6 Chaomans Letchworth
Job No. **188** Elevations South BB
as proposed

Stage: Stage 3
Status: **Non-material amendment**

South Elevation South BB as Proposed

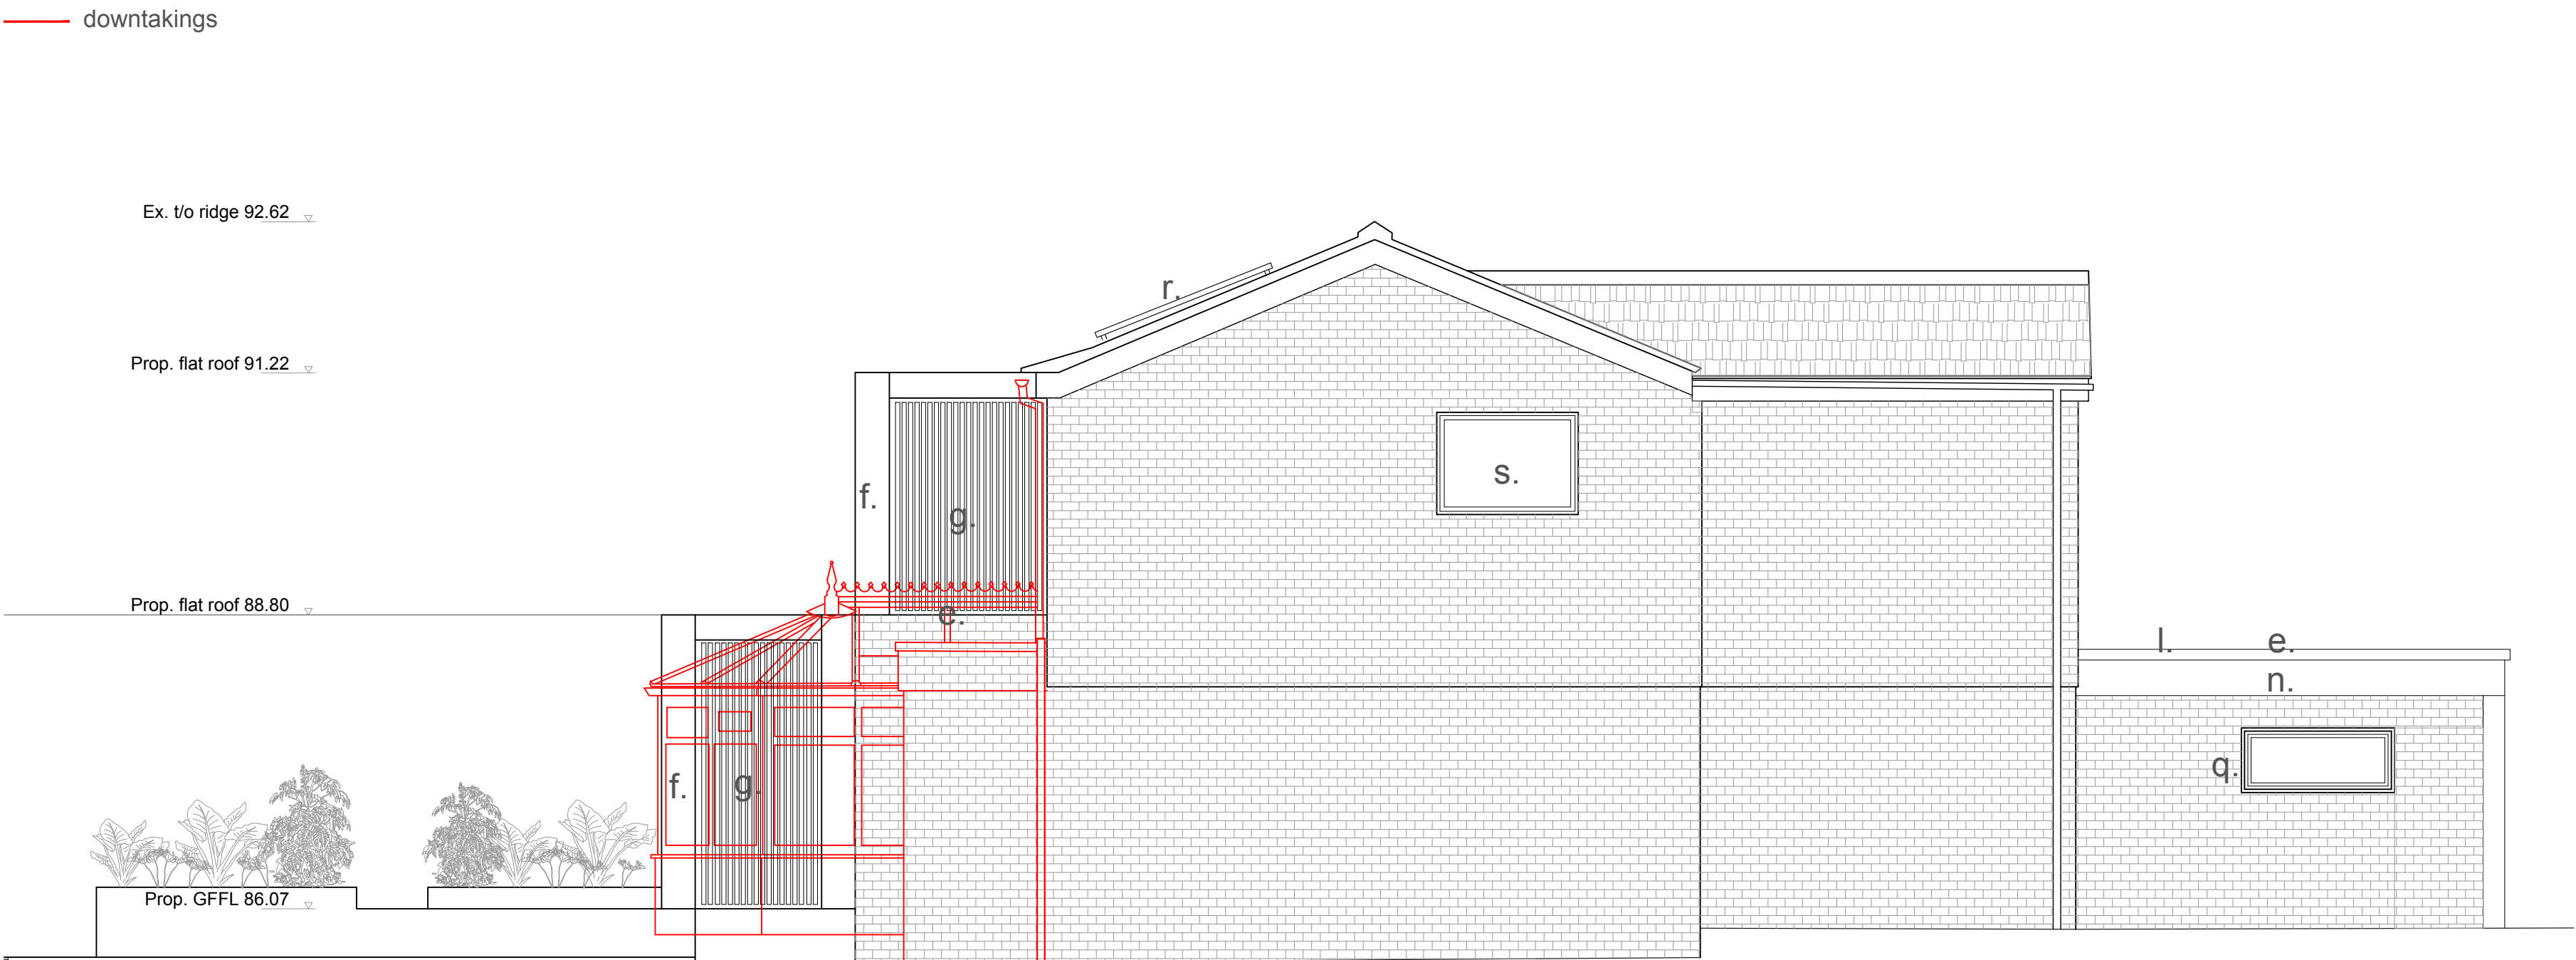
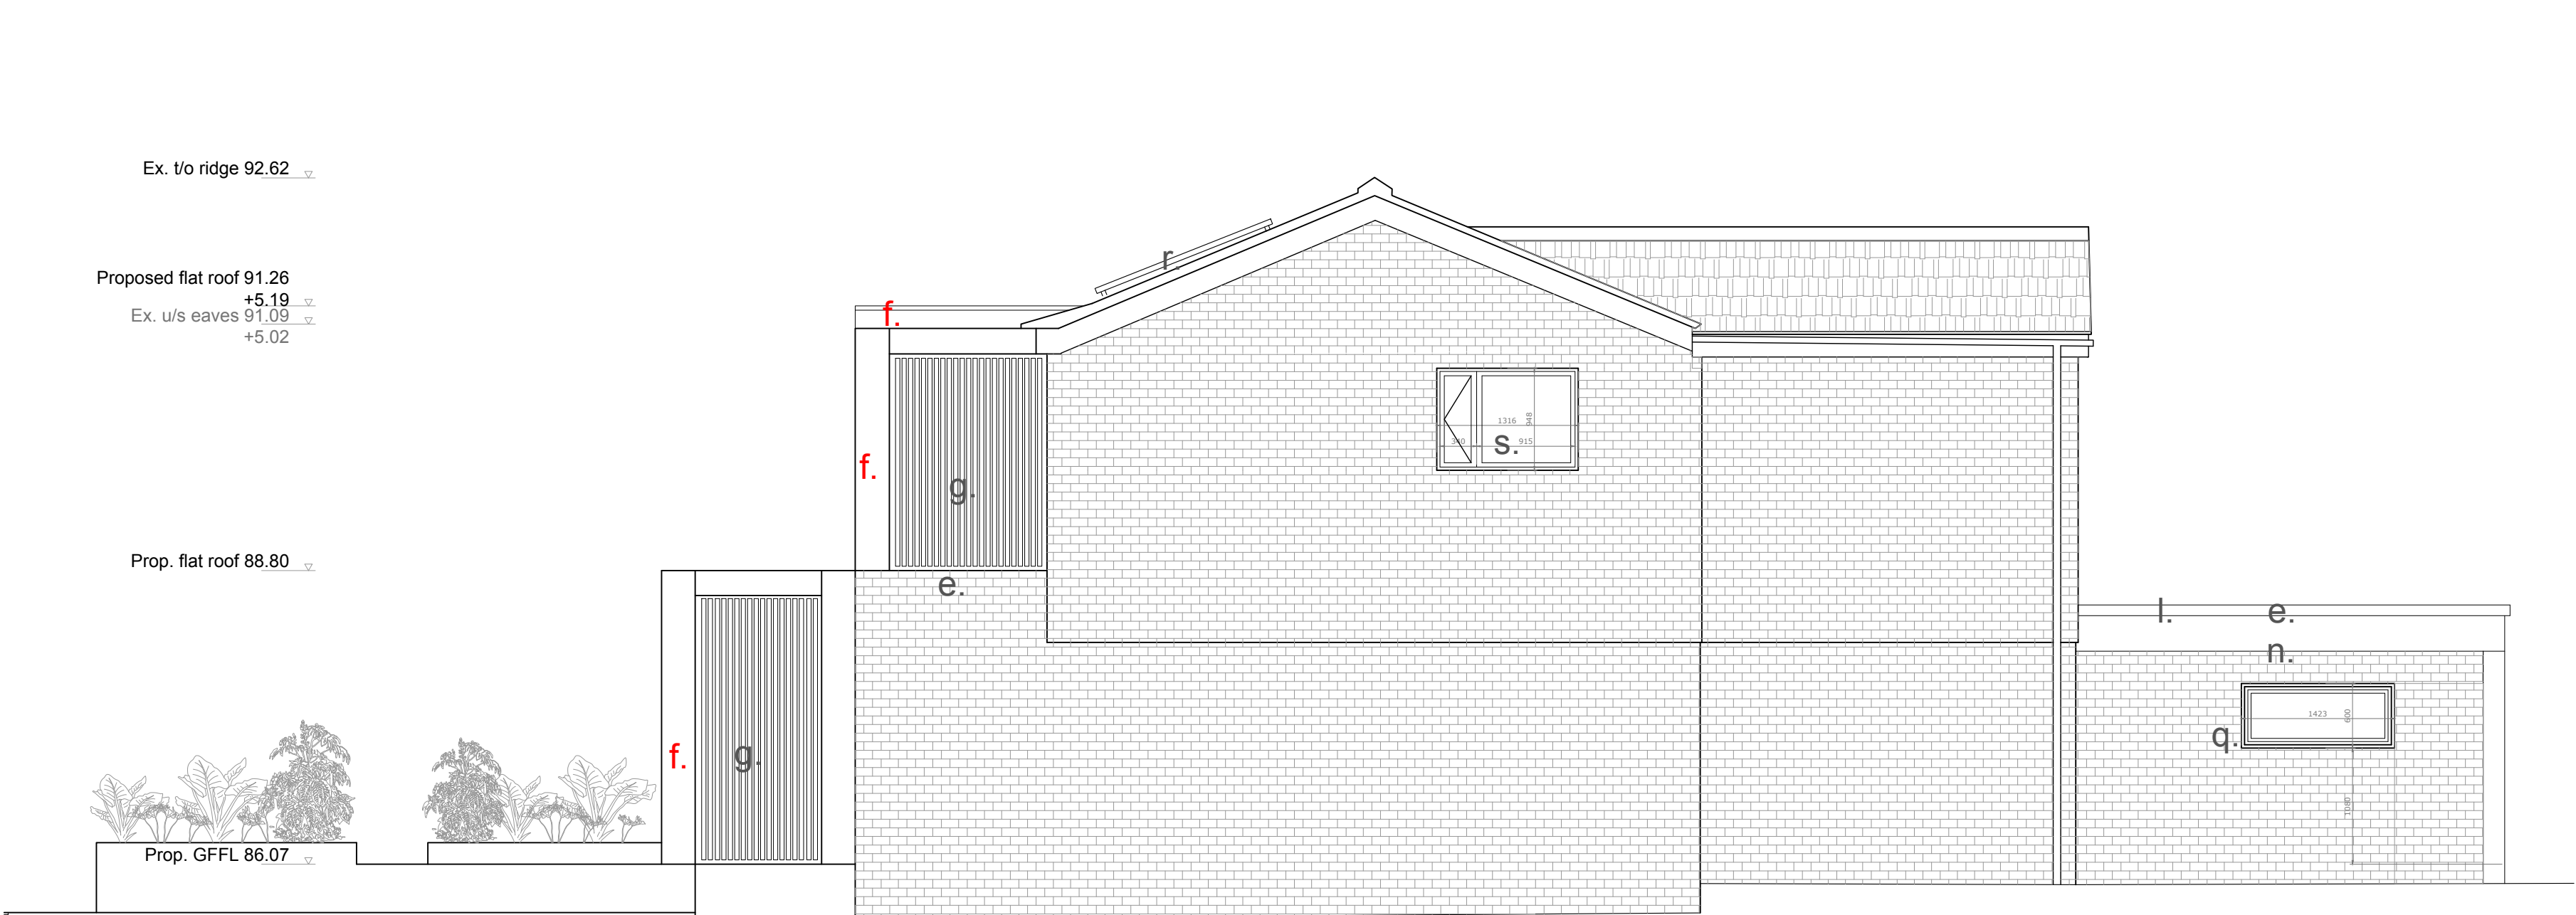
- a. Replace white UPVC existing windows with **aluminium** window - white
- b. New timber front porch door with fixed glazing panel
- c. Existing brick wall
- e. New rooflight
- f. New aluminium RAL 7013 cladding frame**
- g. New **iroko** timber cladding and louvered screen
- h. Existing side gate
- i. New brick wall to match existing
- j. New slimline aluminium sliding doors bronze anodised
- k. New flat roof
- l. Widflower flat roof
- m. Aluminium flashing **RAL 7013**
- n. White fascia
- o. New door - wood
- p. New slimline aluminium windows **RAL 7013**
- q. Oak frame for window
- r. New PV panels
- s. New **white aluminium** window white to match the adjacent windows (**frosted glazing**)
- t. Replace existing UPVC windows with aluminium window RAL 7013**
- u. Seamless glazed balustrade**
